ROANOKE COUNTY

ADDENDUM NO. 1 TO ALL BIDDERS/OFFERRORS:

Reference – IFB 2021-062

Description: Bent Mountain Center “Change-of-Use” & Interior Renovations

A1.03
PROJECT NO. 03160018.00

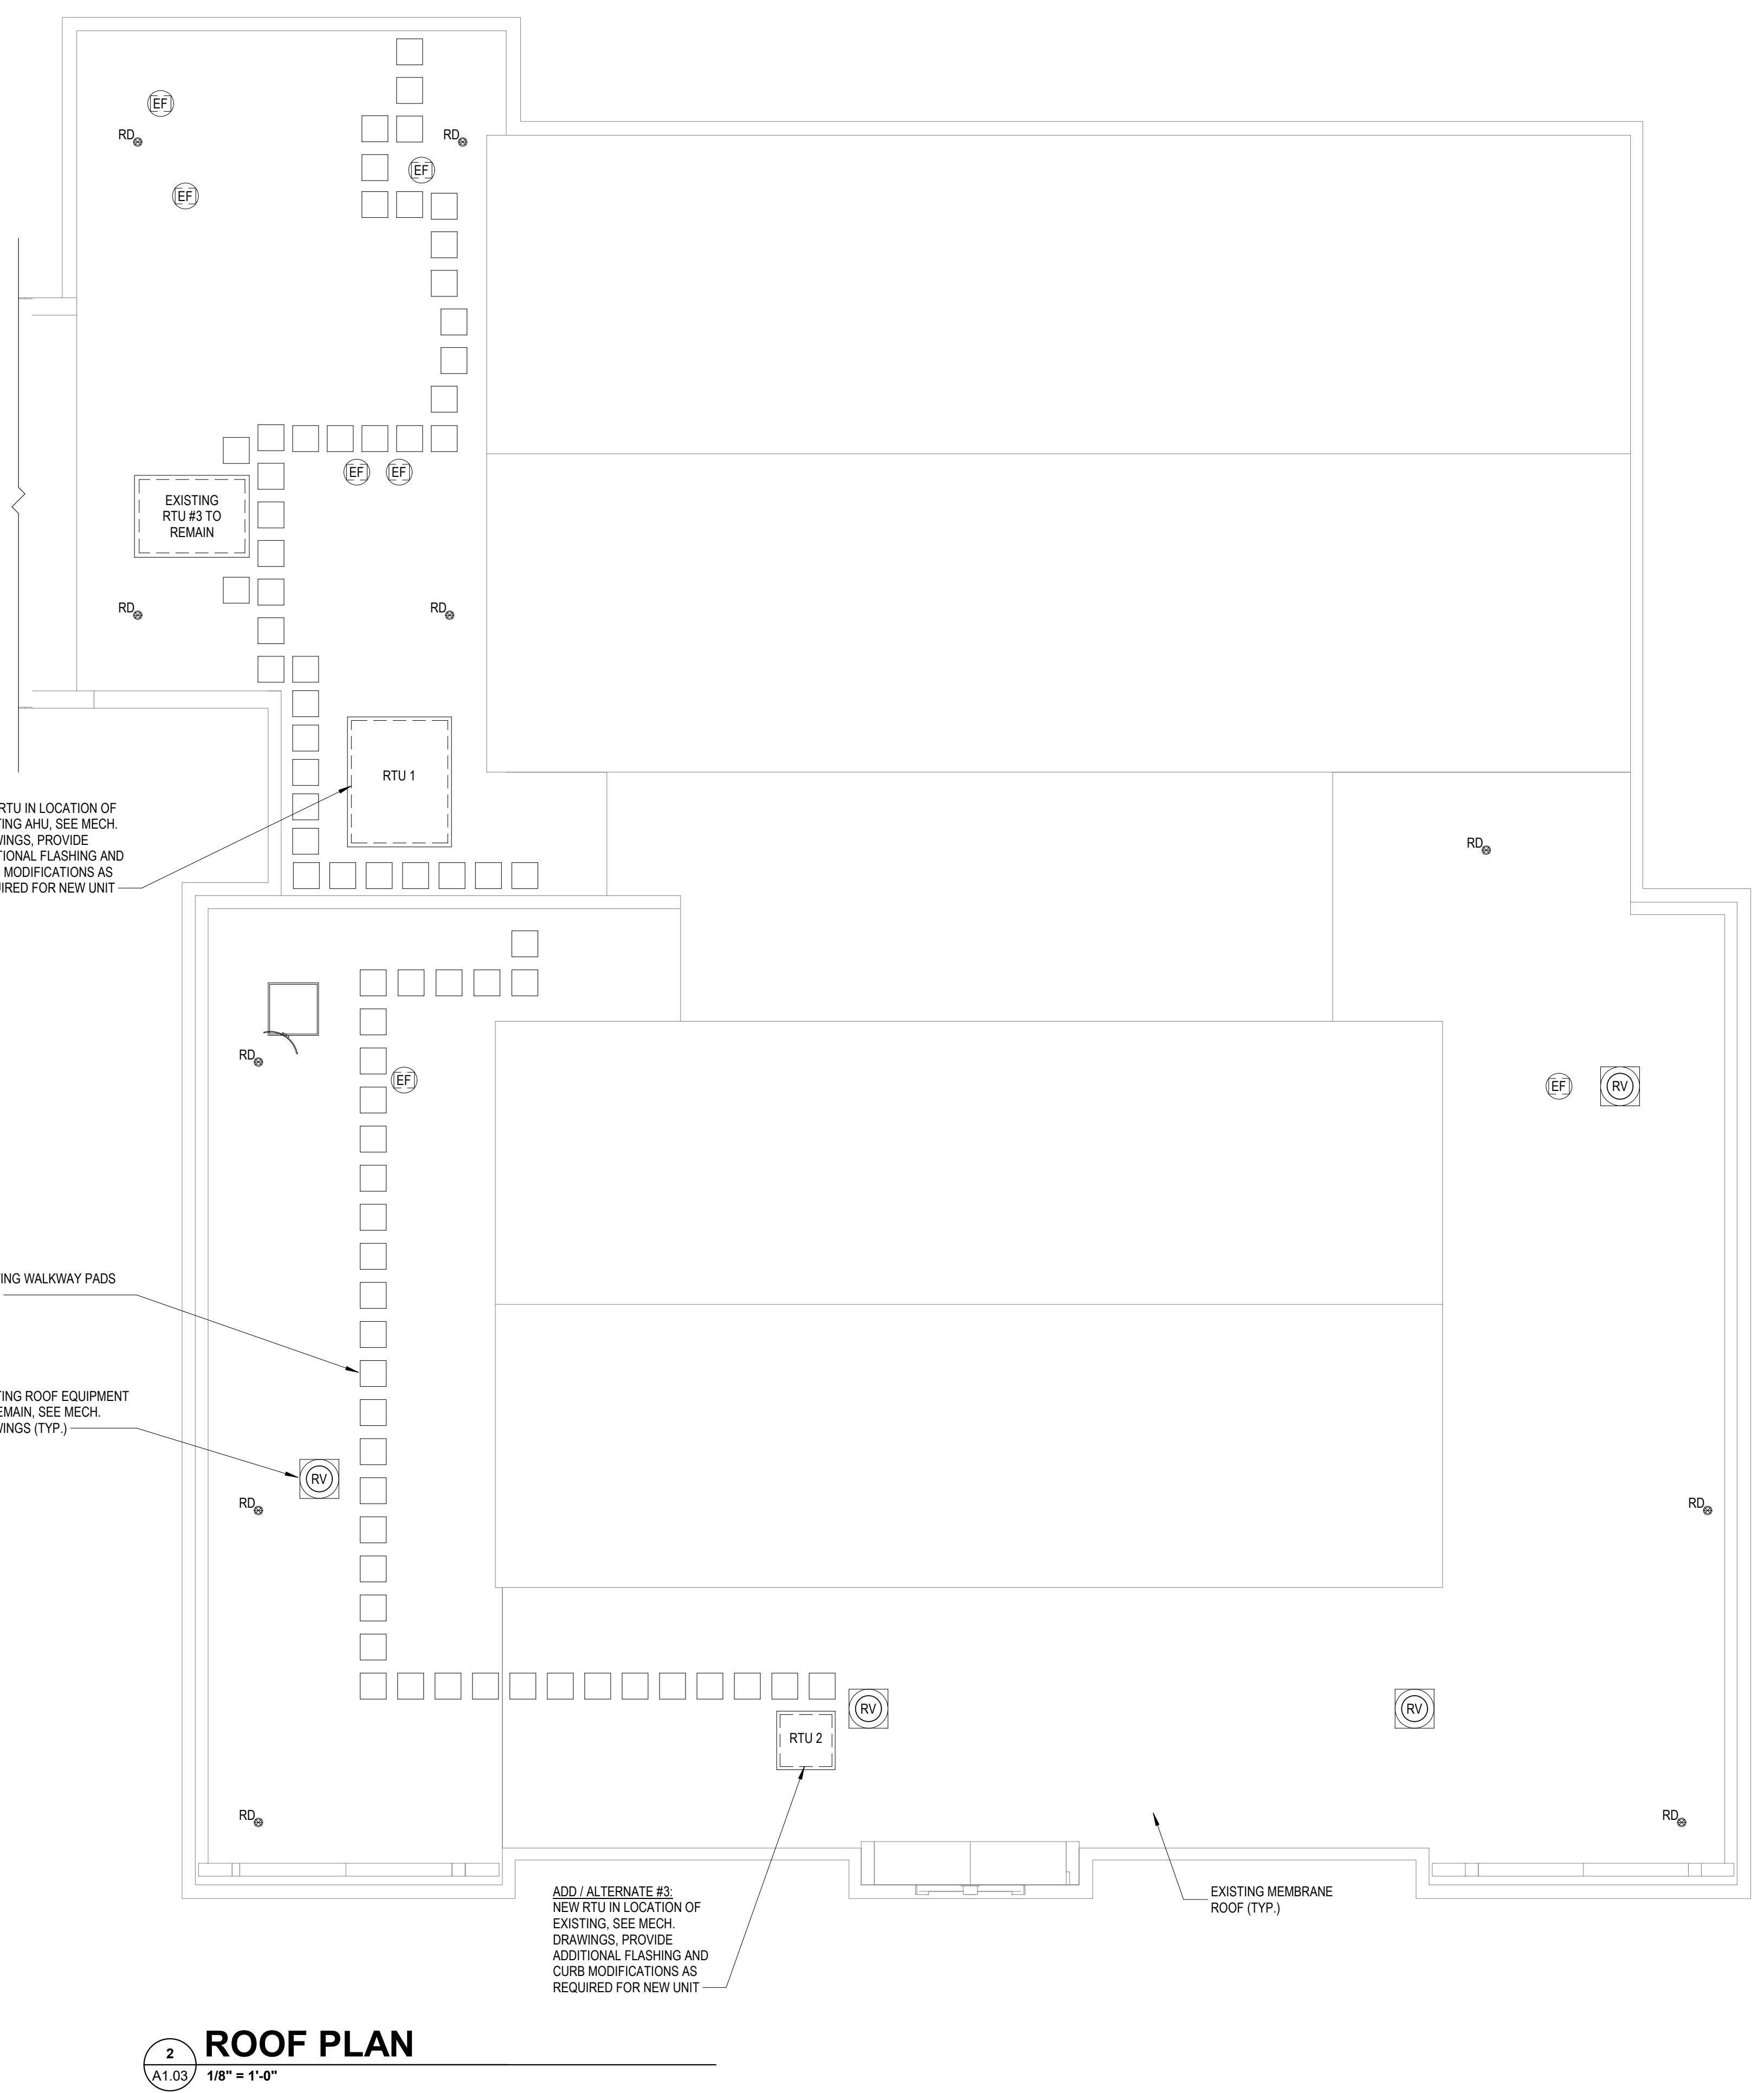
11. Sheet A1.03 – Add/Alternate #3: Note advises that RTU #3 is to be removed and replaced. On the same drawing, a separate note denotes RTU #2 as the RTU of interest. An additional note labels existing RTU #3 to remain. Please advise.
Drawing sheets A1.03 and M3.02 have been revised/updated so the RTU numbers are correct and agree. Add/Alternate #3 is for the replacement of RTU #2.

LIST OF ADD/ALTERNATES

THE FOLLOWING LIST INCLUDES ITEMS TO BE BID AS SEPARATE FROM THE BASE BID.

ADD/ALTERNATE #1: INSTALL OF NEW ACCESSIBLE LIFT FOR GYM STAGE, AS SHOWN ON SHEET A1.03, INCLUDING NEW POWER FEED SPECIFICALLY SHOWN IN ELECTRICAL DRAWINGS.

ADD/ALTERNATE #2: RE-LAMP ALL EXISTING LIGHT FIXTURES AS NOTED ON ELECTRICAL SHEETS E2.1 (SHEET SPECIFIC NOTE 7) AND E3.1 (GENERAL NOTE 1).

ADD/ALTERNATE #3: REMOVE AND REPLACE RTU #2 AS NOTED IN MECHANICAL DRAWINGS.

ADD/ALTERNATE #4: PROVIDE NEW CONTROLS SYSTEM FOR HVAC SYSTEM AS NOTED ON SHEET M4.01

SCOPE OF WORK FOR CONTROLS:

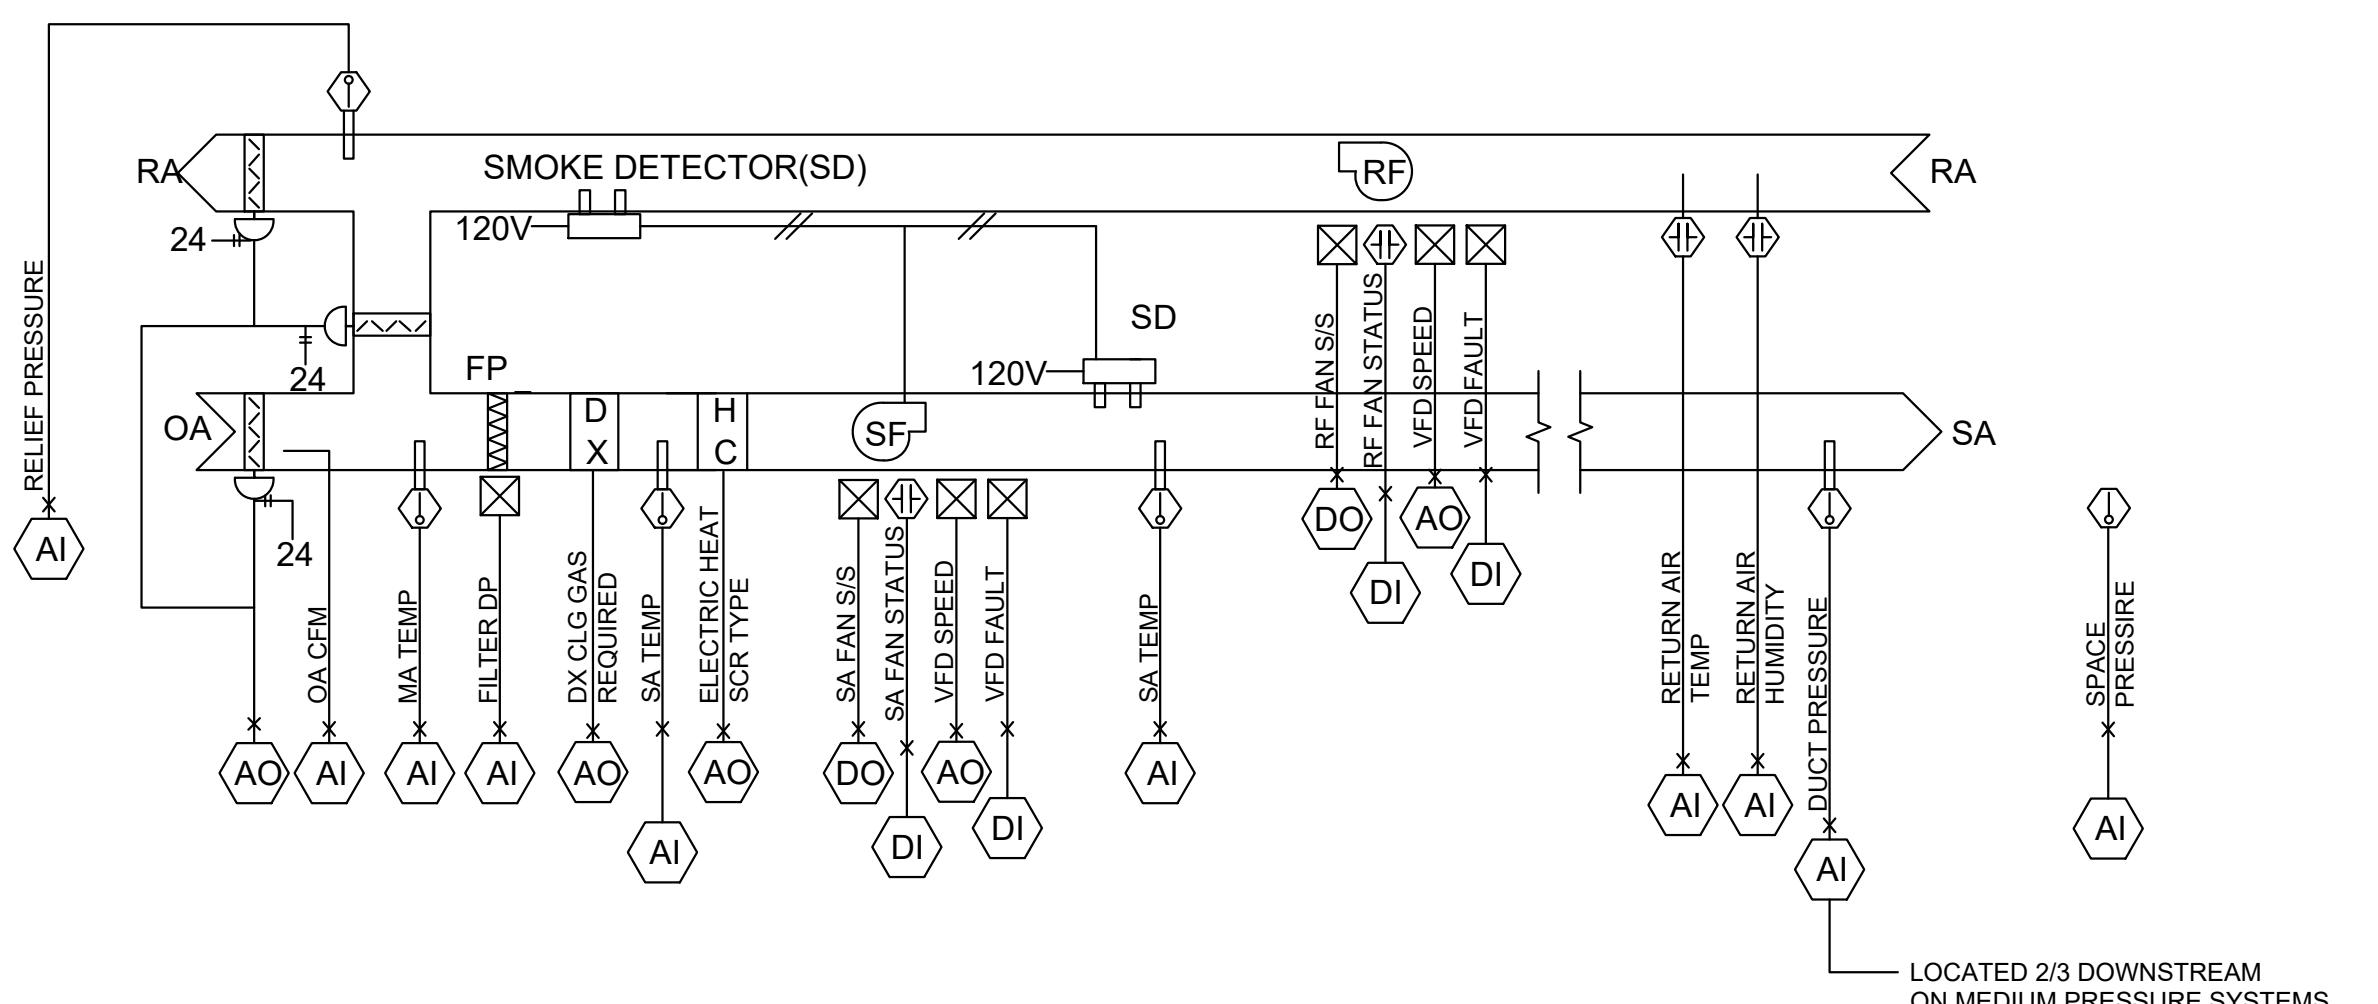
29. Per scope of work for controls on Sheet M4.01, the system front-end controls shall be expanded to accommodate the new equipment. What is the existing system in the building so that the appropriate vendor can be contacted in preparation for proposed expansion and integration of new equipment?

THE BUILDINGS EXISTING METASYS CONTROLS SYSTEM BY JOHNSON CONTROLS SHALL BE EXPANDED TO ACCOMMODATE AND GAIN FULL CONTROL OF ALL NEW MECHANICAL EQUIPMENT BEING ADDED IN THIS PROJECT INCLUDING ALL WORK IN AREAS BEING RENOVATED. THE CONTROLS CONTRACTOR SHALL FURNISH AND INSTALL A COMPLETE DIRECT DIGITAL TEMPERATURE CONTROL SYSTEMS (DDC) FOR ALL NEW EQUIPMENT AND ADD ONTO OR REPLACE EXISTING CONTROLLERS AS REQUIRED. FOR ANY NEW CONTROL PANELS, A LOCAL AREA NETWORK (LAN) SHALL BE PROVIDED TO INTERCONNECT THE SYSTEMS WITHIN THE BUILDING.

PROVIDE ALTERNATE PRICING TO REPLACE THE EXISTING JOHNSON CONTROLS METASYS BUILDING AUTOMATION CONTROLS SYSTEM IN ITS ENTIRETY WITH A NEW, FULLY FUNCTIONAL BUILDING AUTOMATION SYSTEM BY TRANE. THE NEW SYSTEM SHALL BE DIRECT DIGITAL CONTROL (DDC) TYPE CAPABLE OF CONTROLLING THE BUILDING MECHANICAL SYSTEMS AND MAINTAIN BUILDING CLIMATE. THE NEW SYSTEM SHALL BE COMPRISED OF SENSORS, CONTROLLERS, AND SHALL PROVIDE A NEW CENTRALIZED FRONT END CONTROLLER TO NETWORK ALL NEW AND EXISTING MECHANICAL EQUIPMENT AND SHALL PROVIDE WEB BASED ACCESS AND CONTROL OF THE SYSTEMS. THE EXISTING SYSTEMS TO BE INTEGRATED INCLUDE: 6 EXHAUST FANS, THE PACKAGED ROOFTOP UNIT SERVING THE LIBRARY, RTU-2 (OR EXISTING OFFICE UNIT), THE GYM AIR HANDLER, AND THE EXTERIOR BUILDING AND SITE LIGHTS.
